Addendum No. 2

Twin Falls School District Harrison and Morningside HVAC

ADDENDUM NO. 02

Project Name: TFSD Harrison HVAC Replacement
Address: Twin Falls, Idaho

Sheet No:
A9.01

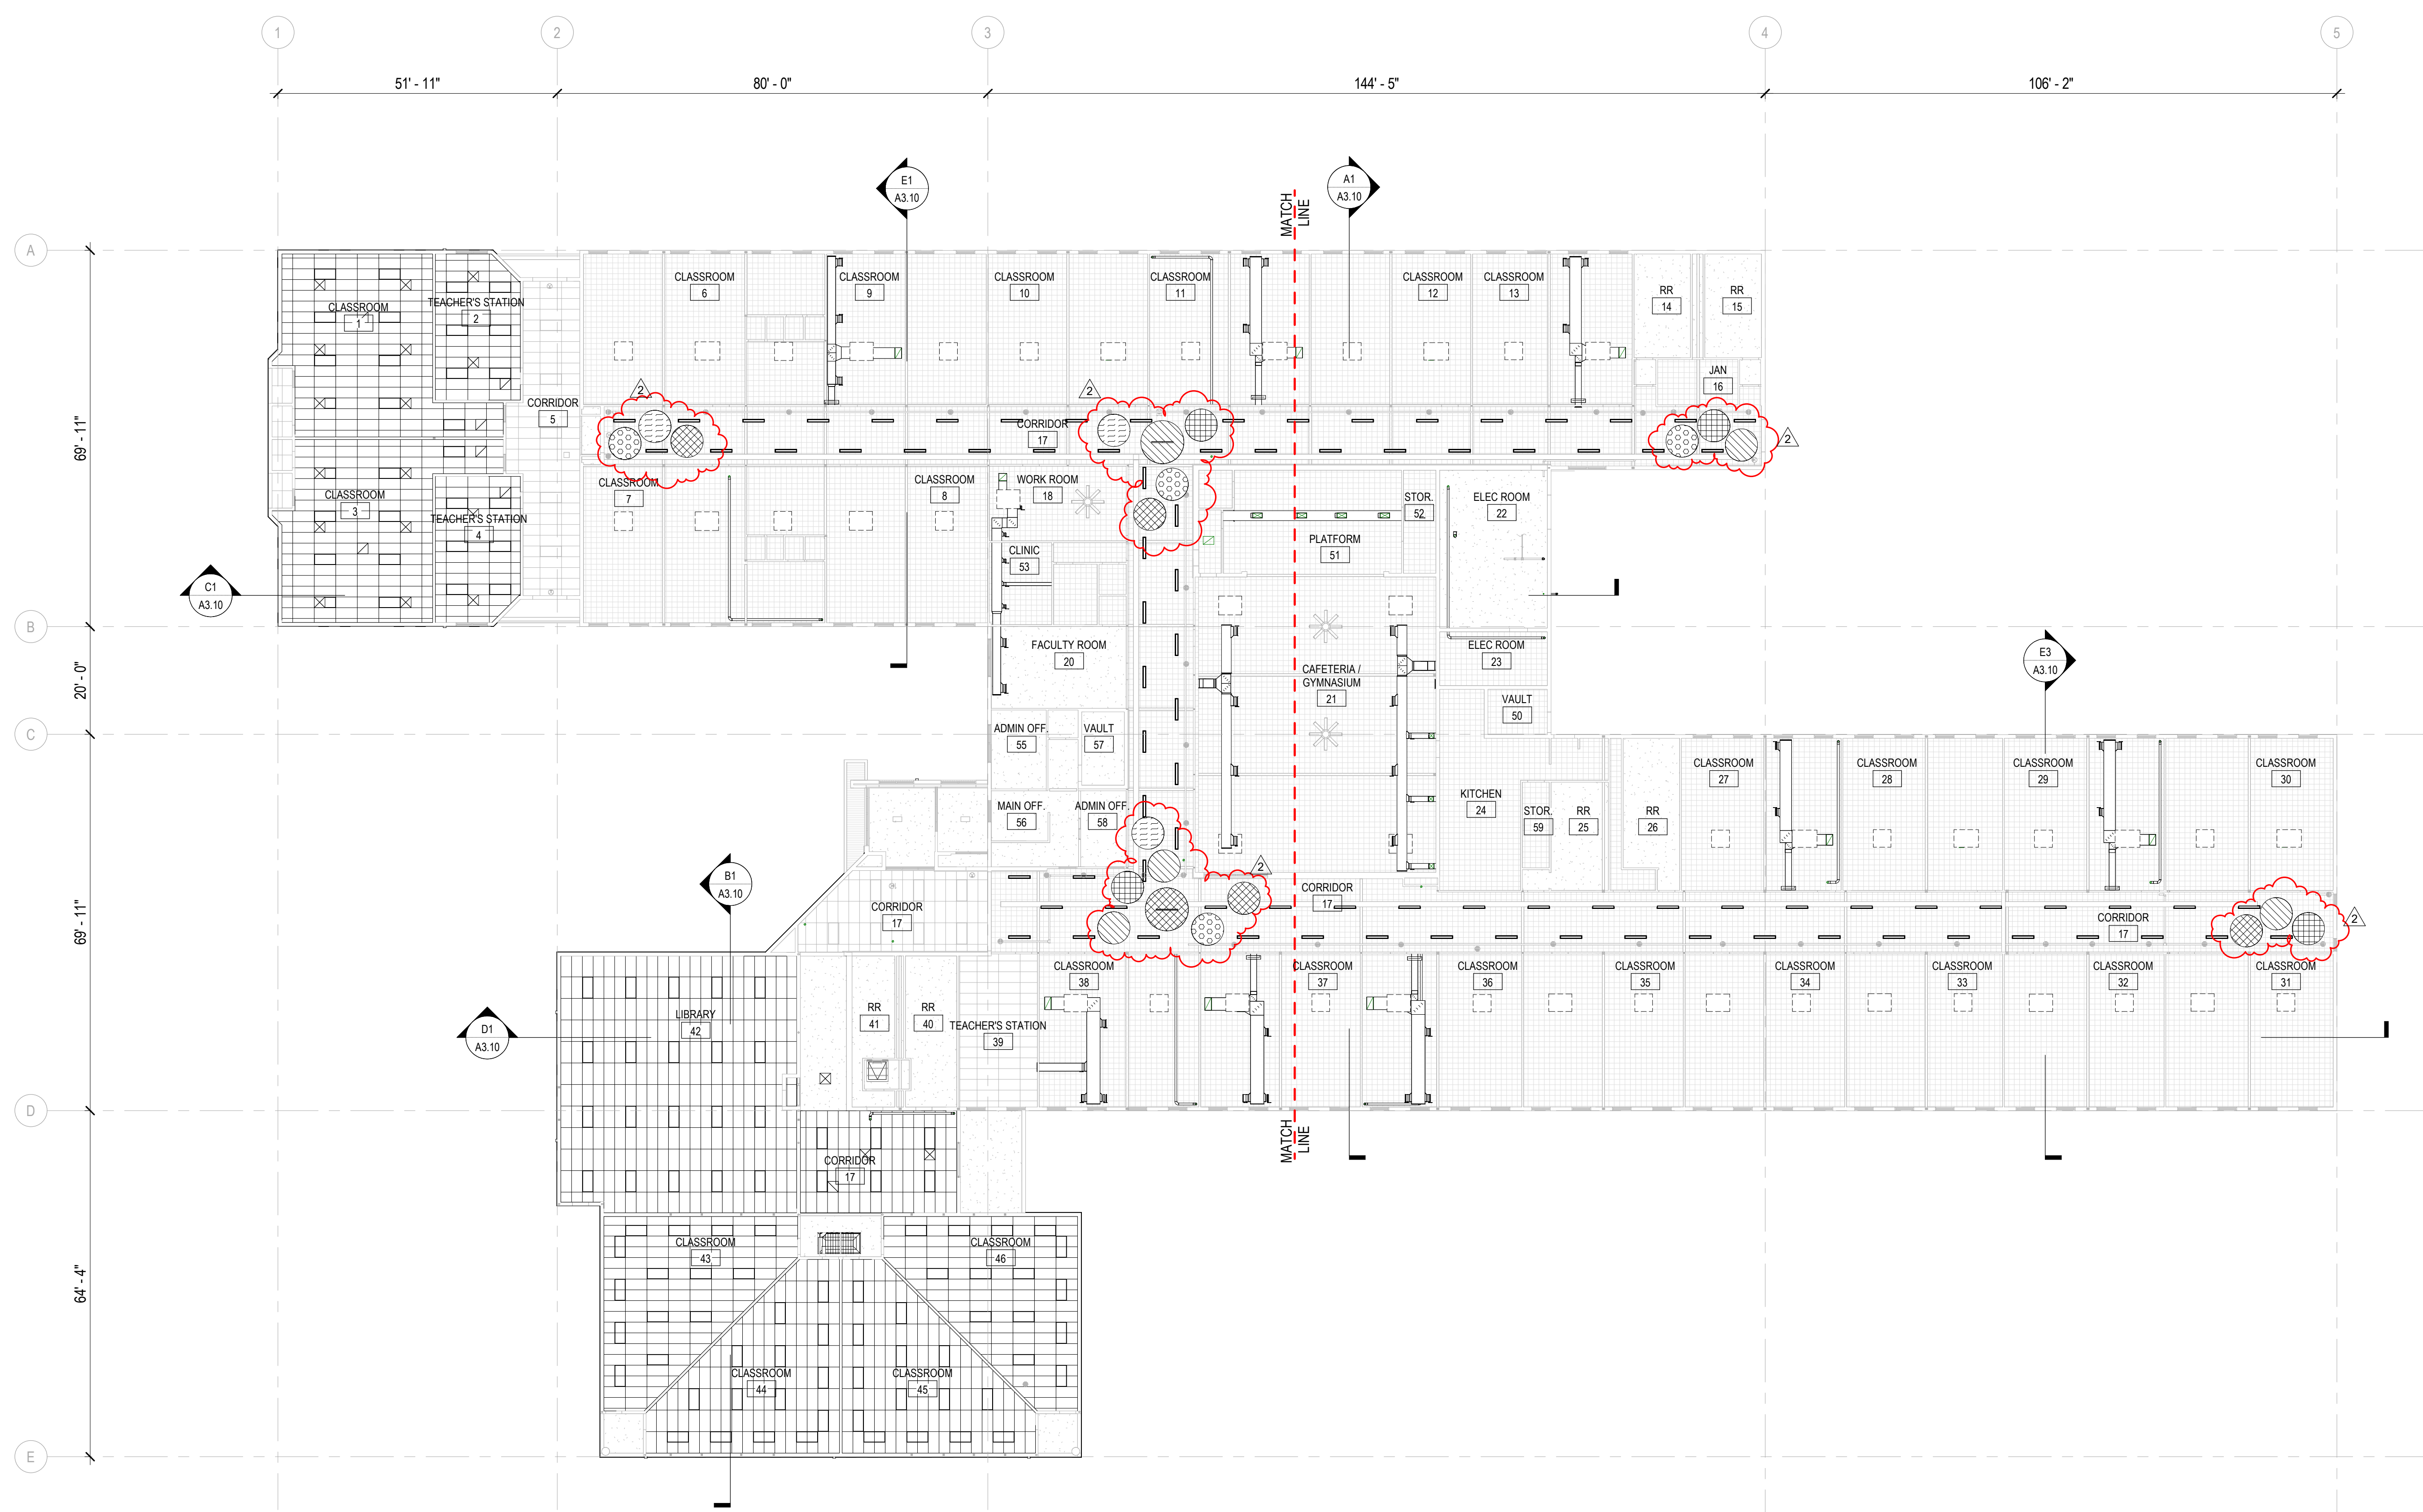
- **A9.01 – COMPOSITE CEILING PLAN**
 - Change 4'-0" ceiling cloud to 6'-0" ceiling cloud
 - Update ceiling grids from 2'-0" x 4'-0" grid to 2'-0" x 2'-0" grid.
- **A9.11 – AREA 'A' CEILING PLAN**
 - Change 4'-0" ceiling cloud to 6'-0" ceiling cloud. Update dimensions and locations of ceiling clouds.
 - Update ceiling grids from 2'-0" x 4'-0" grid to 2'-0" x 2'-0" grid.
- **A9.12- AREA 'B' CEILING PLAN**
 - Change 4'-0" ceiling cloud to 6'-0" ceiling cloud. Update dimensions and locations of ceiling clouds.
 - Update ceiling grids from 2'-0" x 4'-0" grid to 2'-0" x 2'-0" grid.

Sheet No:
A9.12

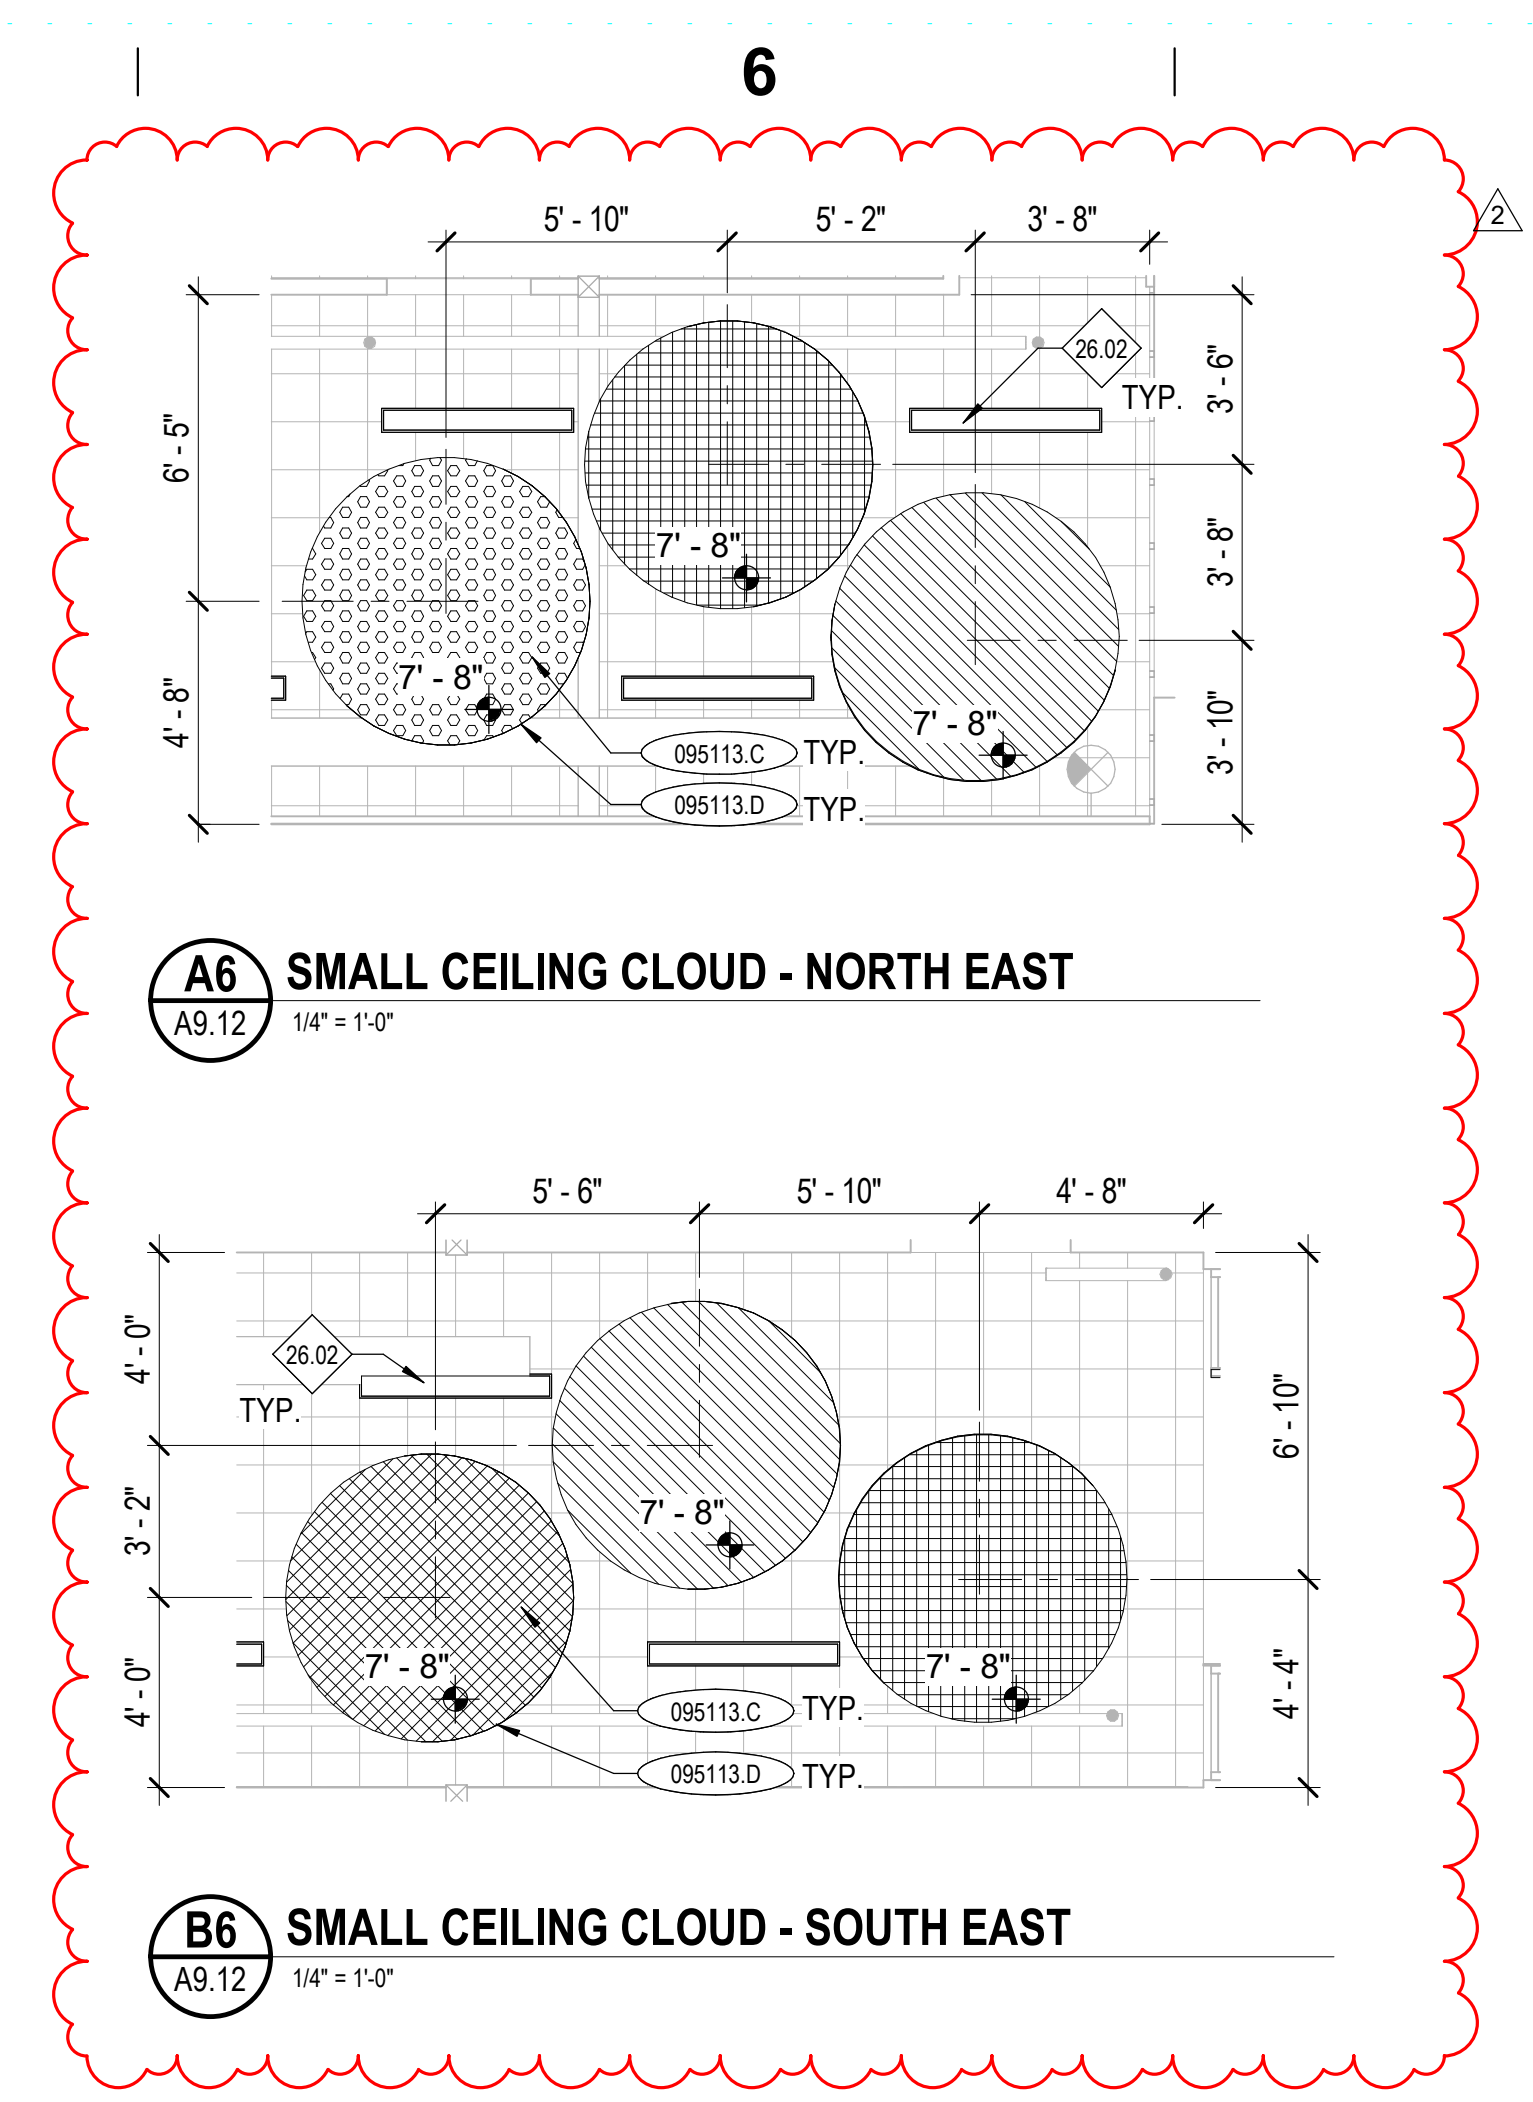
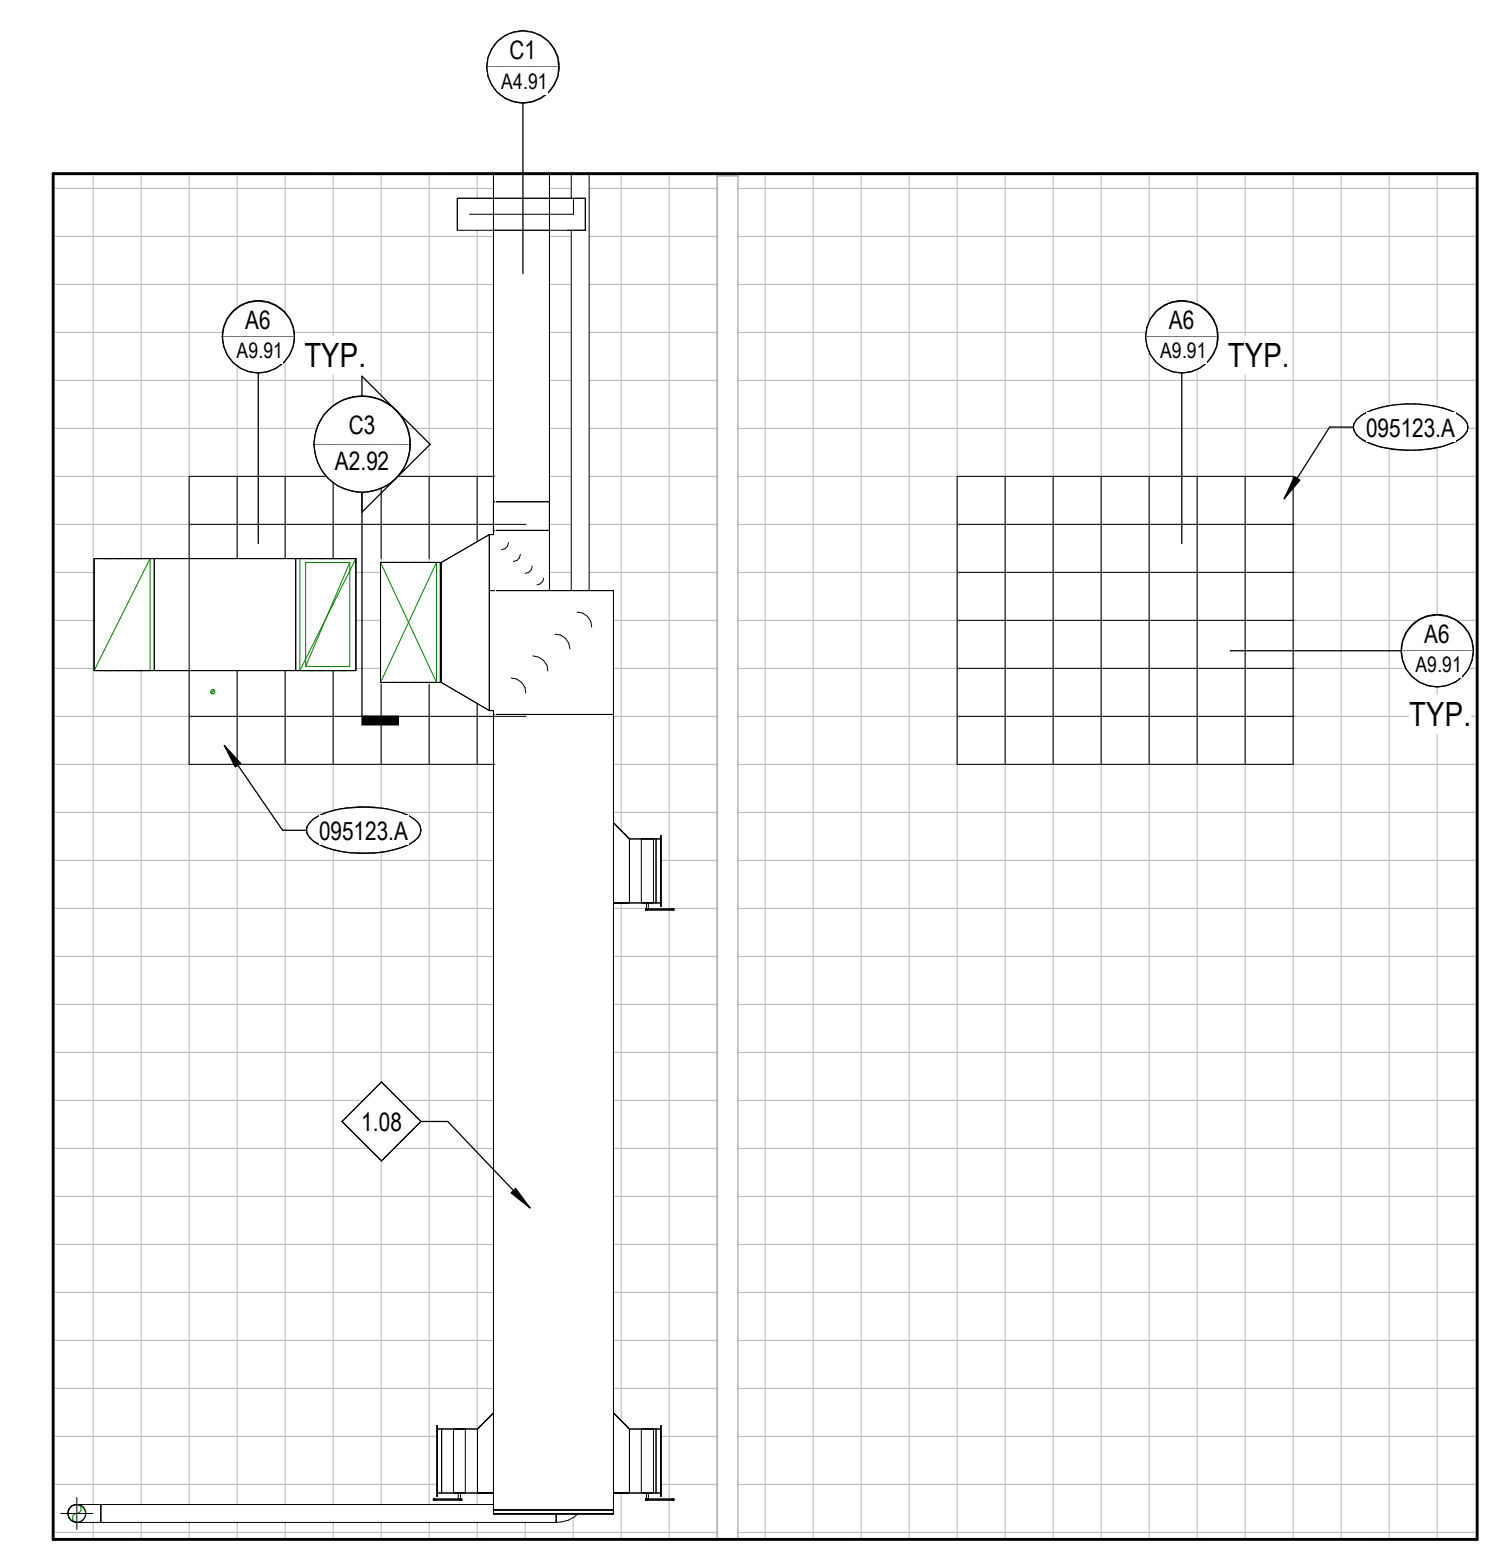
- See attached revised drawings for 2x2 grids at ceiling clouds.
- See attached revised drawings. Note that drawings indicate **6' and 8' DIAMETER**. Not radius.
